Date: April 14th, 2020
Bulletin#: TB2020-02

Technical Bulletin Regarding: Blower Speed Fault

Applicable Models: All Intellihot Models, most affected are iQ751, iQ1001, and iQ1501

Description:

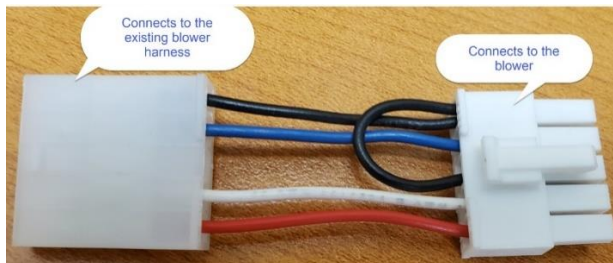
This bulletin is to address blower faults that were previously misdiagnosed. When blower speed faults are shown on the display, error history, or logged in the telliCare system, one of the root causes is signal noise. The signal/electrical noise causes the control board to report an erroneous blower speed fault.

- a. On a multiple HEX unit model such as iQ751, not all blowers may exhibit this blower fault symptom. The error history would show specific blower faults.
- b. On a multiple HEX unit model such as iQ751, a cascading fault may also be present.

Intellihot has a jumper harness (Part# ELC0305) that connects to the existing wiring harness and eliminates the electrical noise. This connector allows for easy field installation. Please refer to MNL0051 for installation instructions of ELC0305.
